**Addendum No. 1  
September 27, 2021**

Project: **Harrisburg Middle School No. 3**  
Harrisburg, South Dakota  
Architecture Incorporated Project #2903

Architect: Architecture Incorporated

8.25

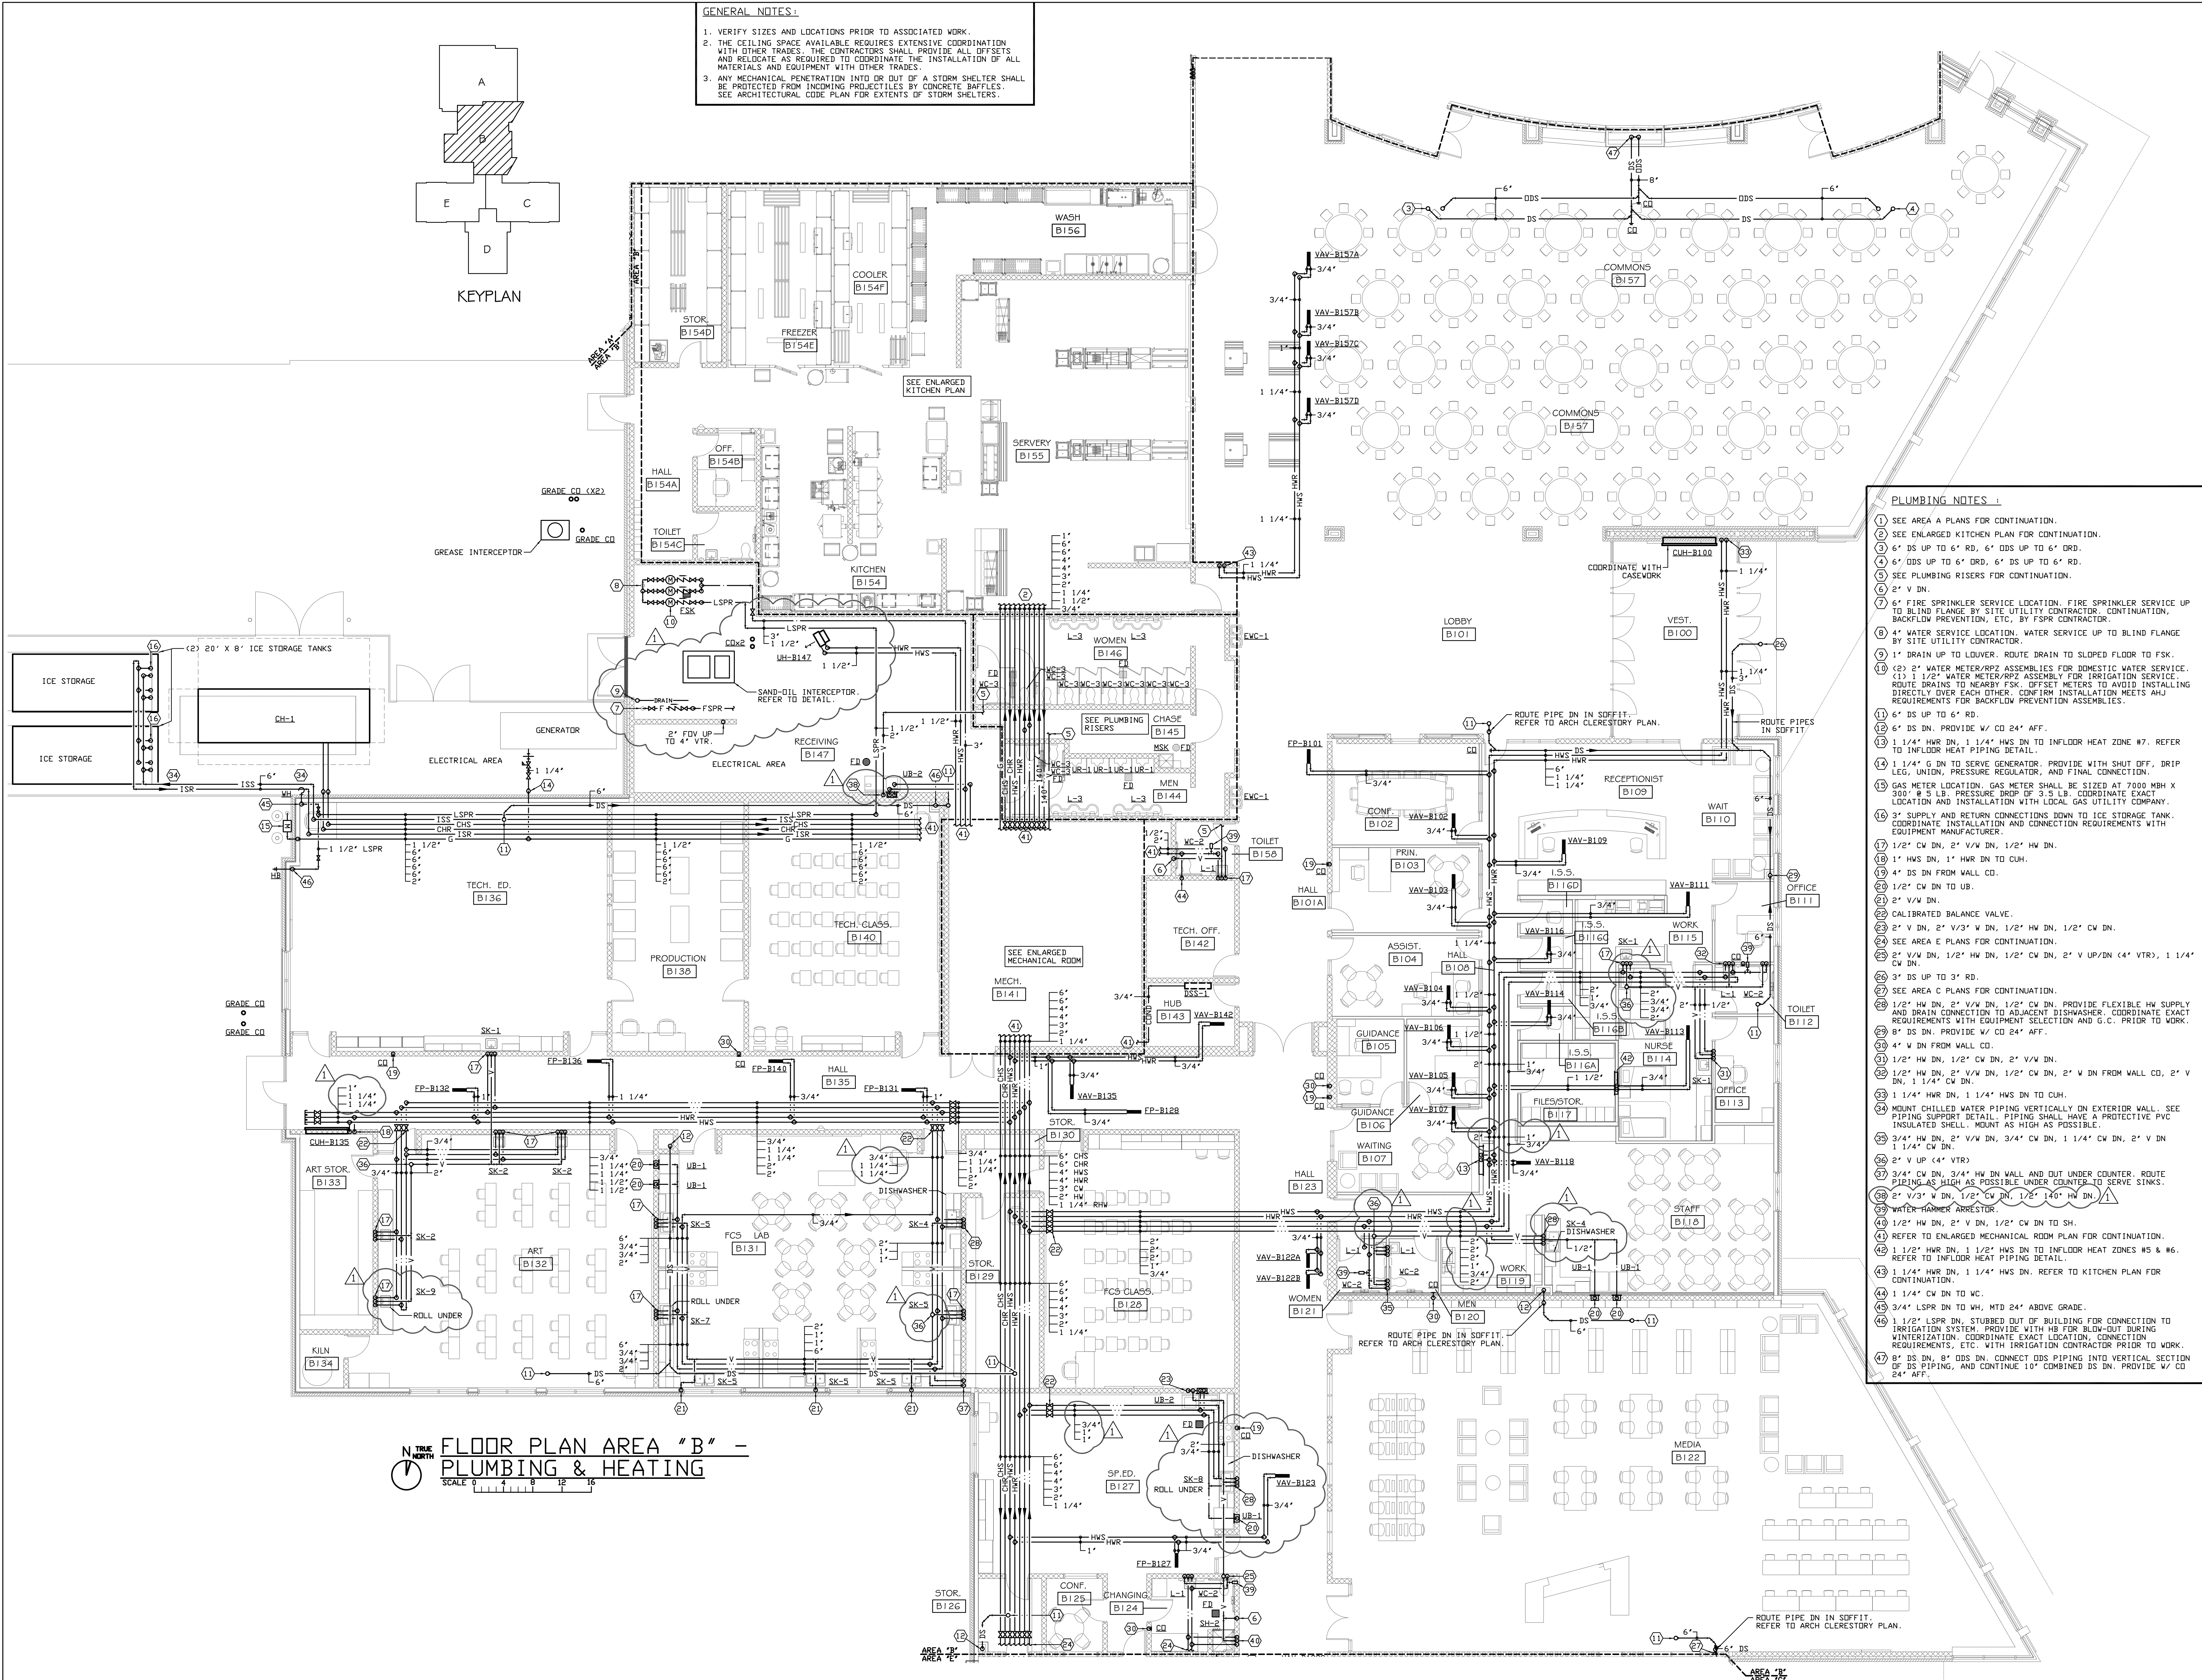
- i) Corrected urinal specification for “UR-1” in Toilet A116.
- 6) SHEET 8.26 – FLOOR PLAN – AREA B – PLUMBING & HEATING
- a) Refer to revised mechanical drawing Sheet 8.26, revision dated 9-27-21, attached to the end of Addendum #1 for the following:

Sheet Contents: **ENLARGED PLANS & RISERS - AREA B - PLMB & HTG**

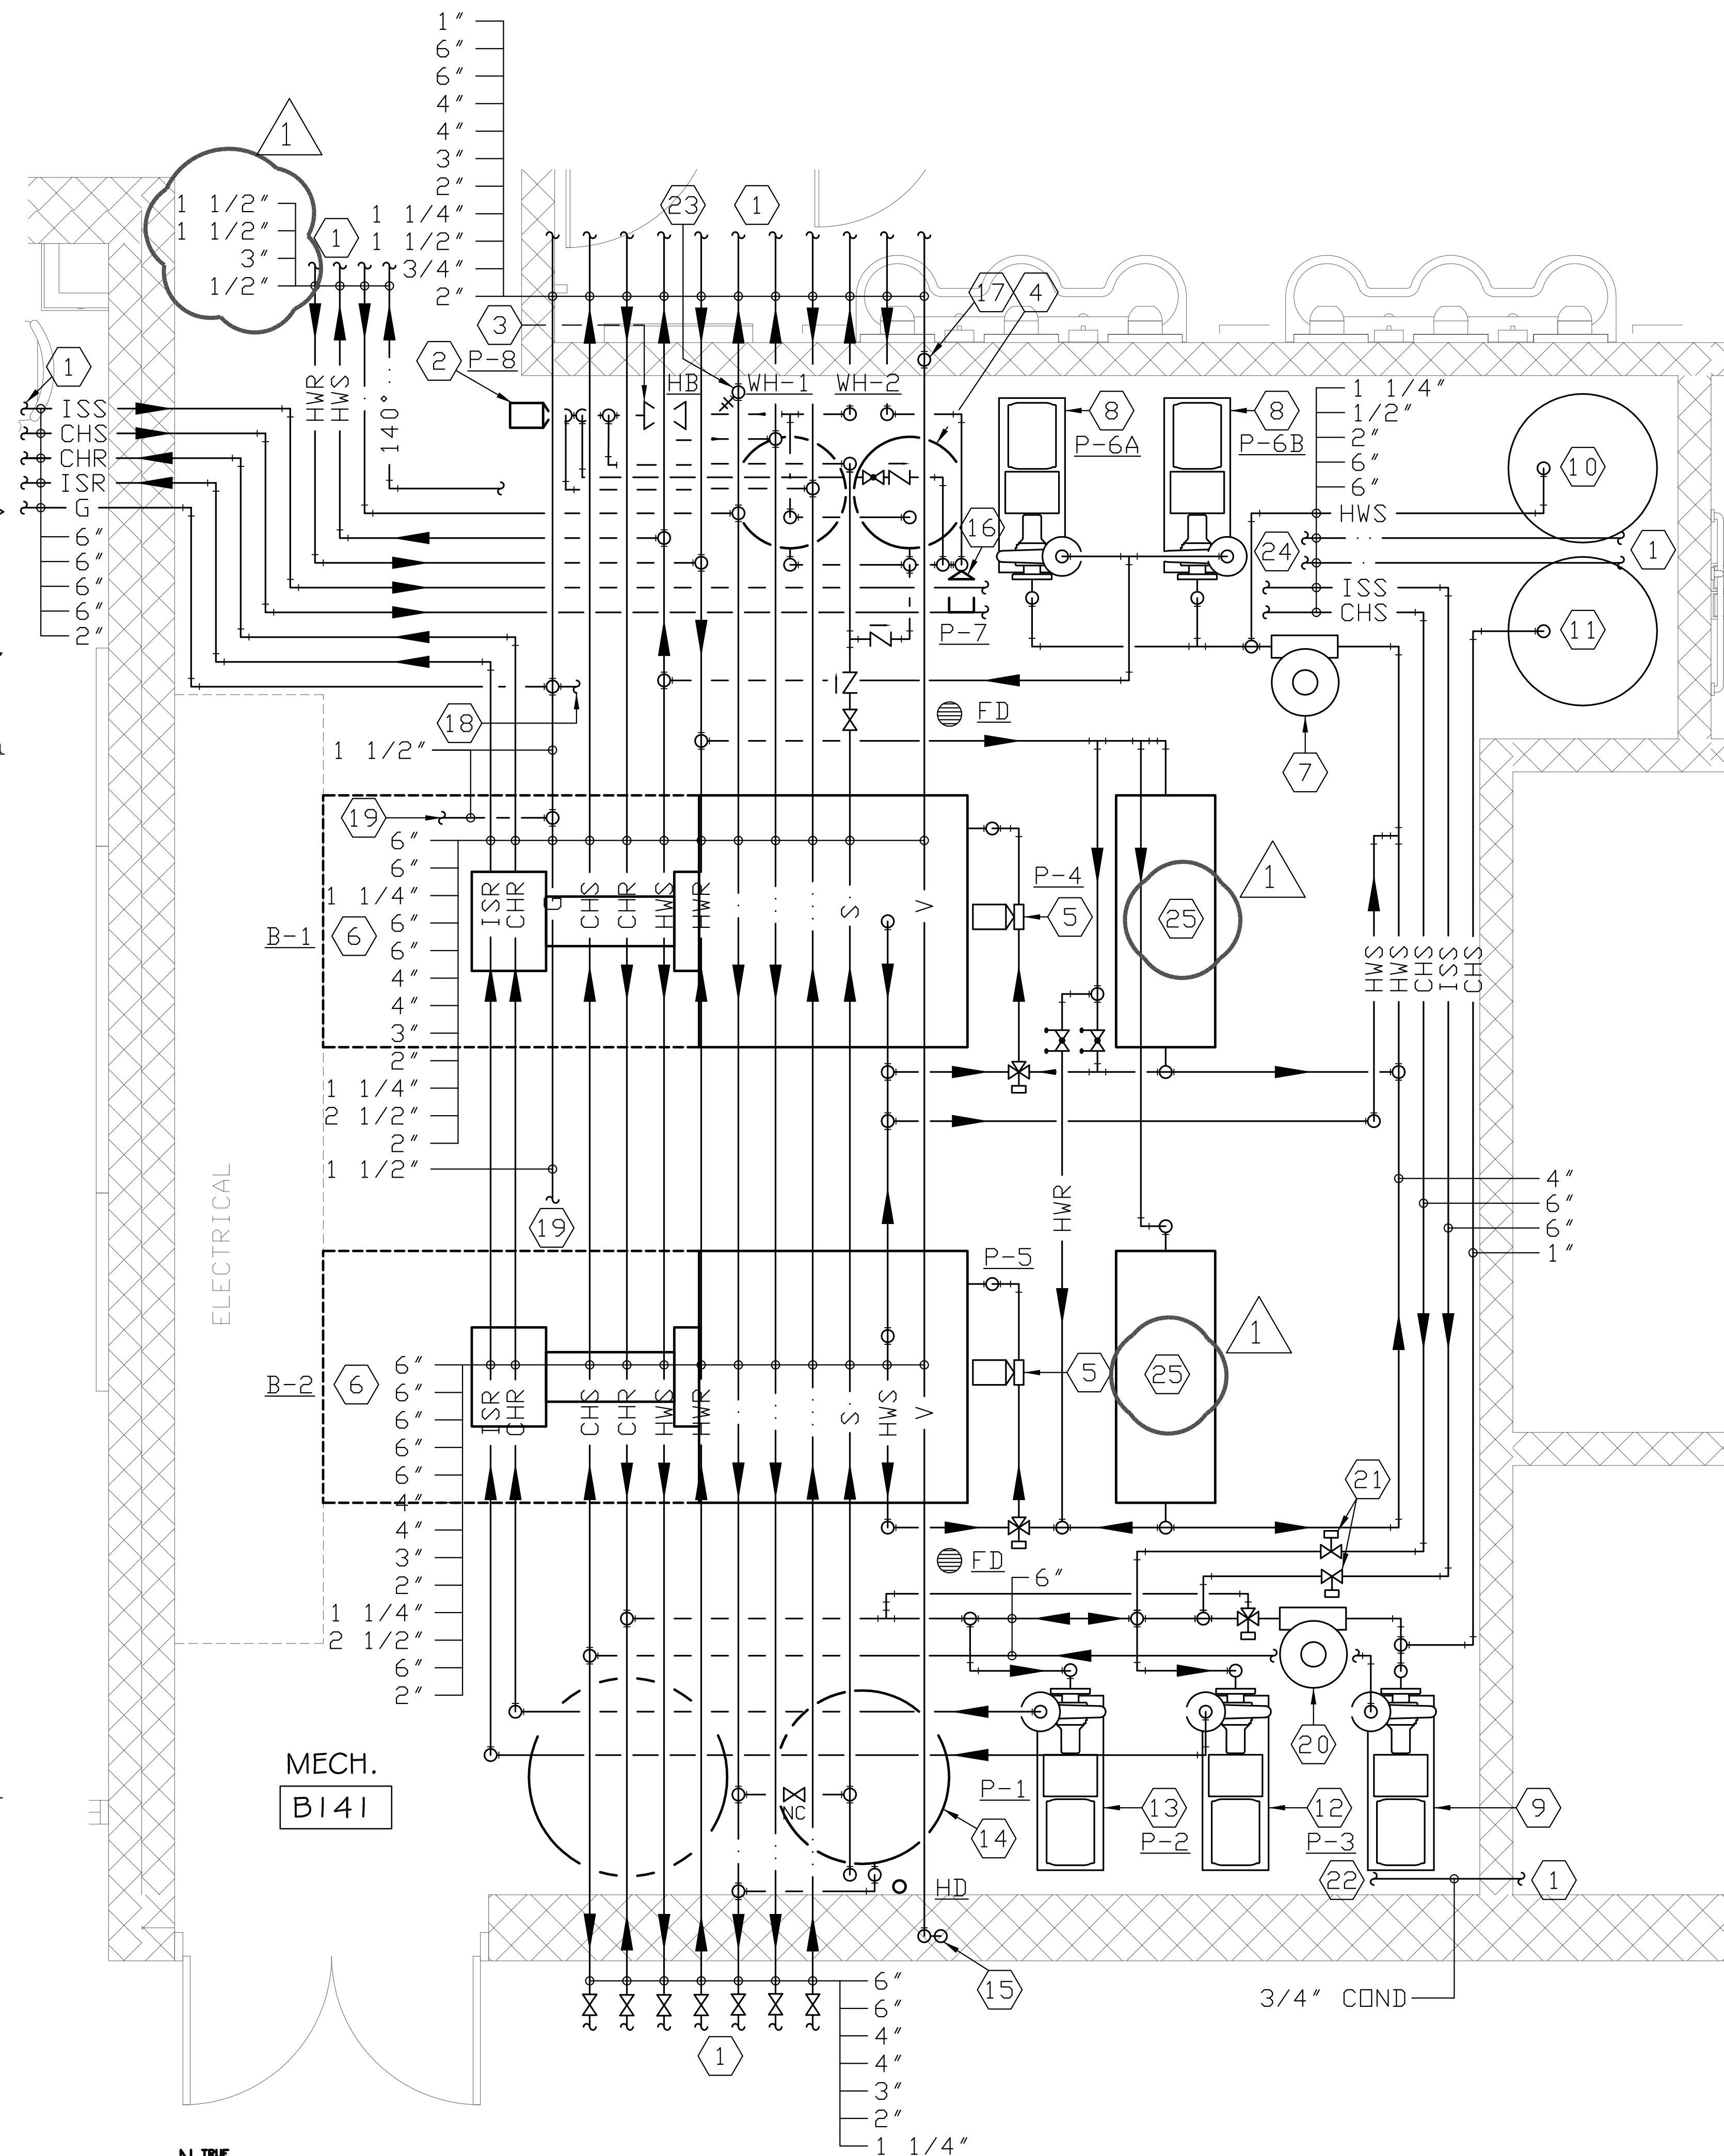
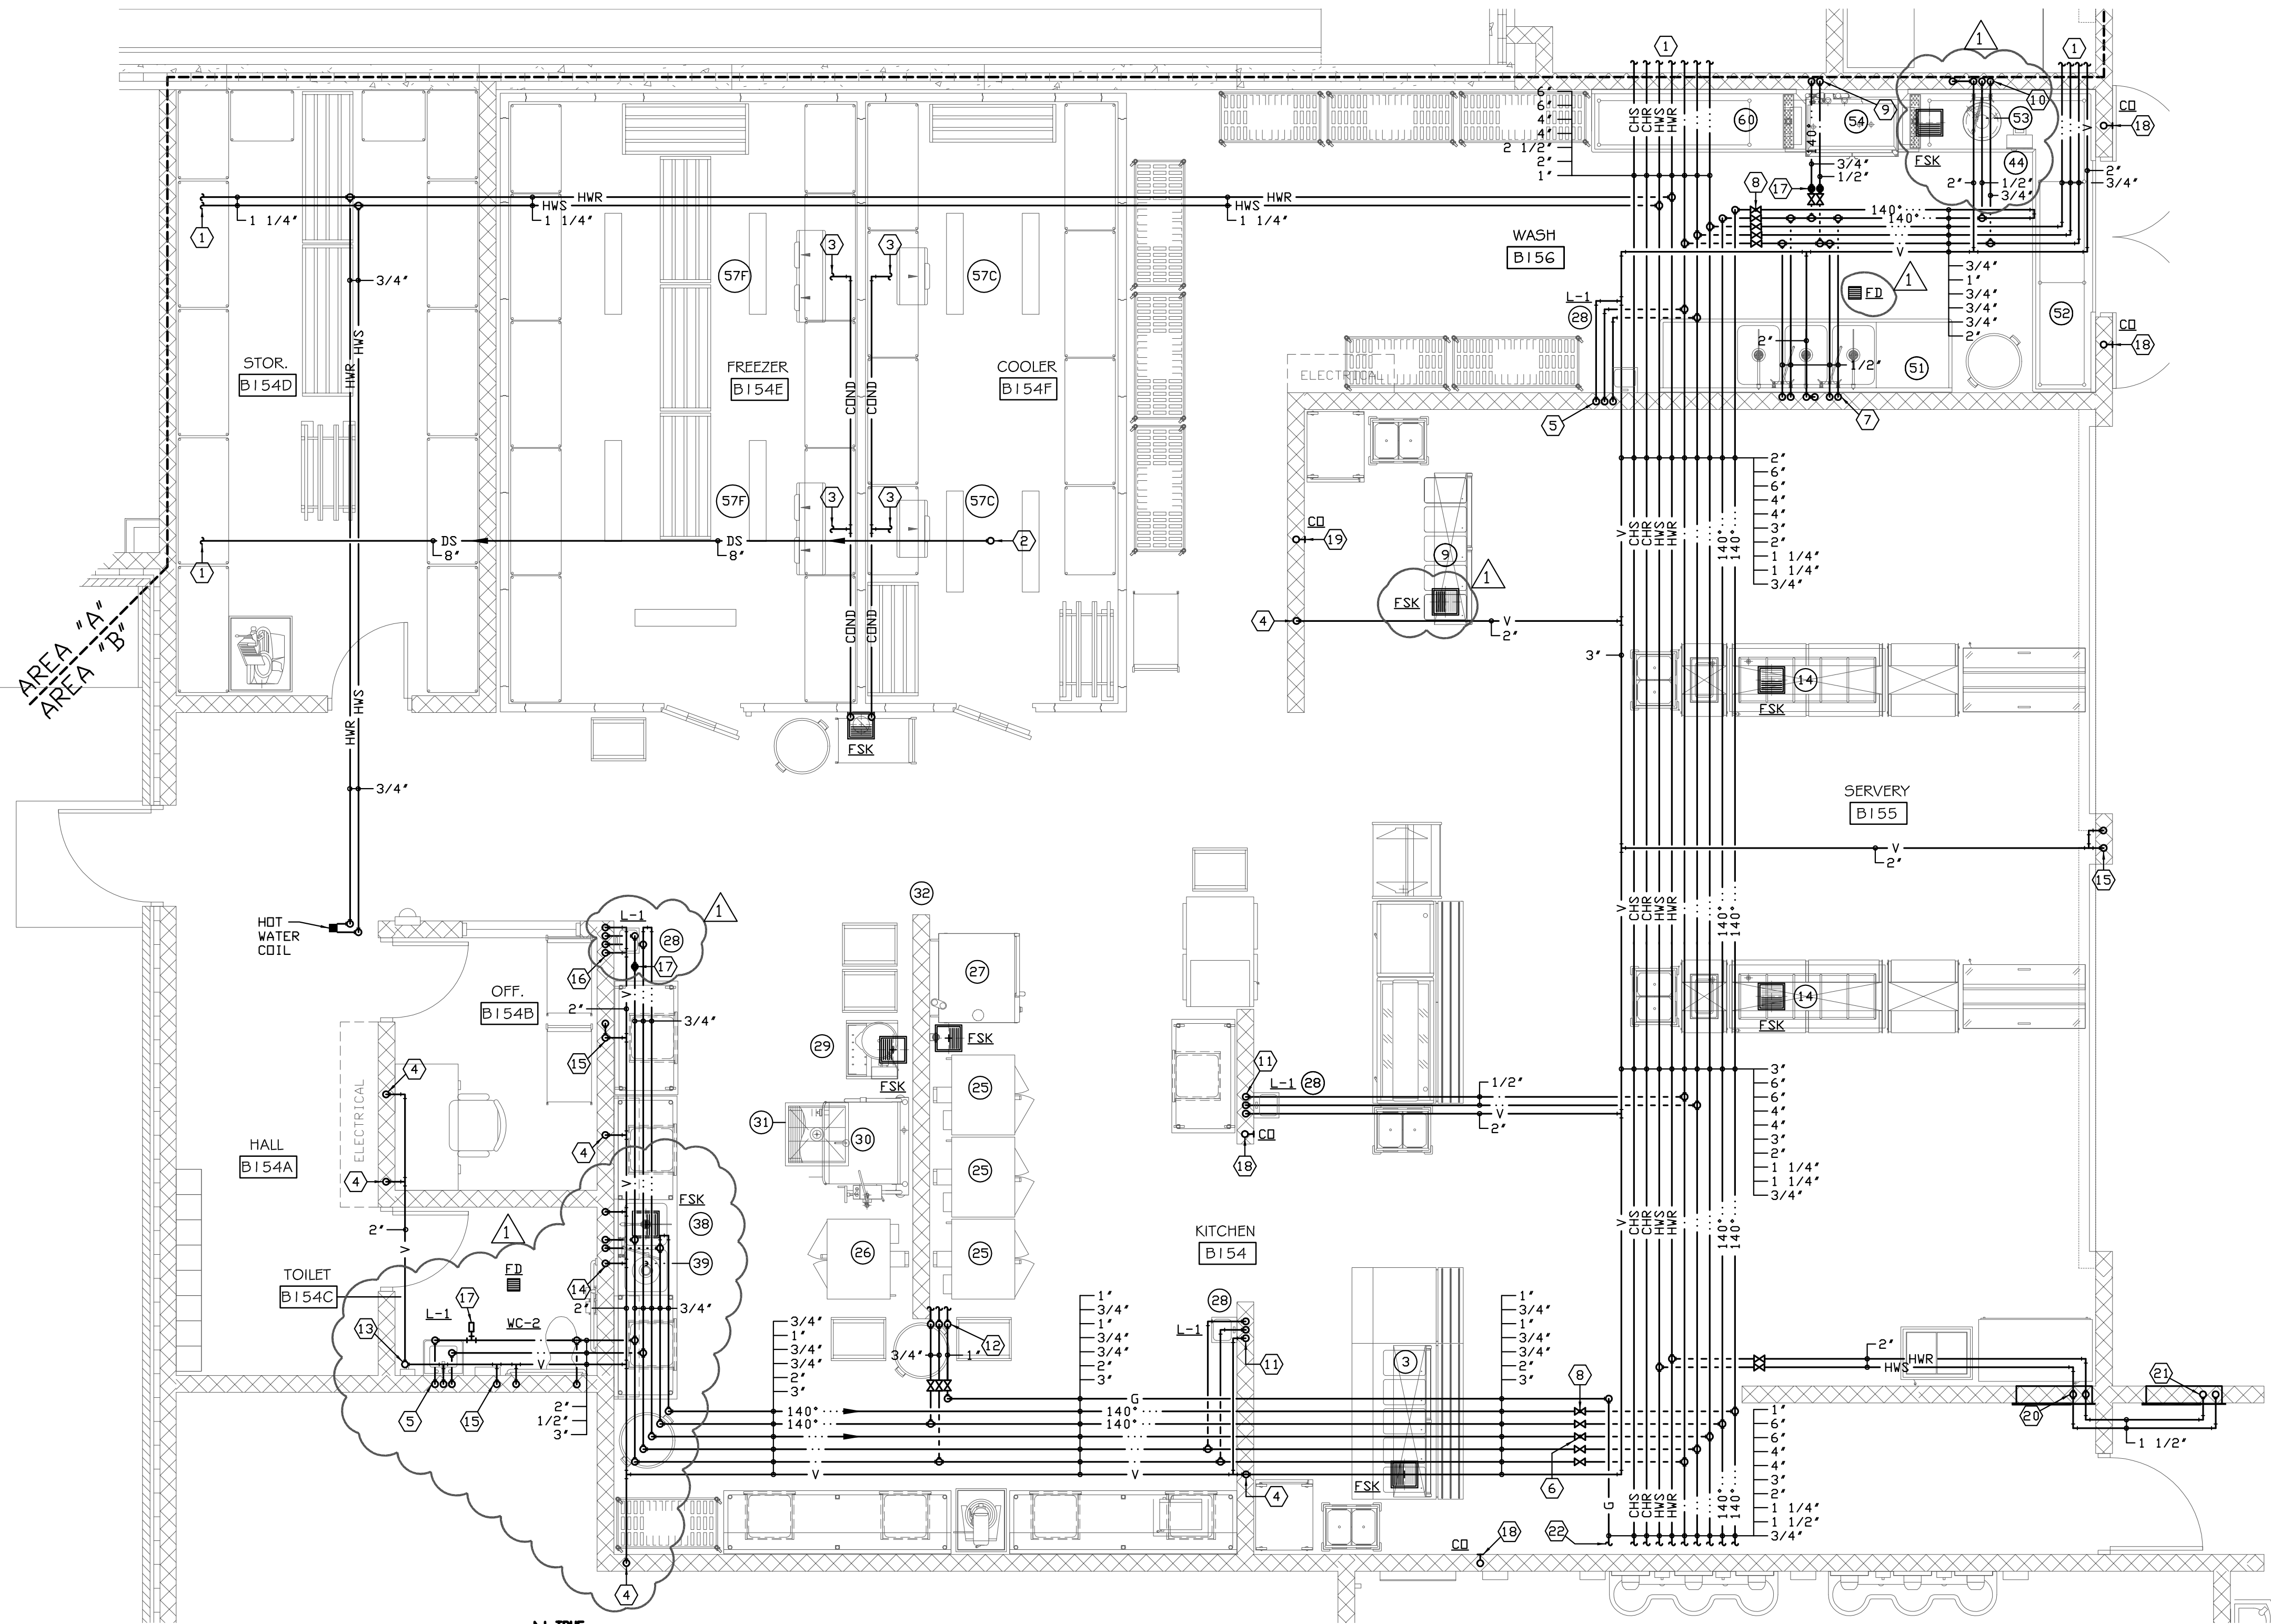
- a) Refer to revised mechanical drawing Sheet 8.31, revision dated 9-27-21, attached to the end of Addendum #1 for the following:
  - i) Add keynote for designation of stack economizer.
  - ii) Revise gas size to water heaters to match associated detail.
  - iii) Add more shock absorbers to “Domestic Riser – B144/B145/B146”.
  - iv) Revise HWS/HWR pipe size out of room to Receiving B147.
  - v) Delete UH-B141.
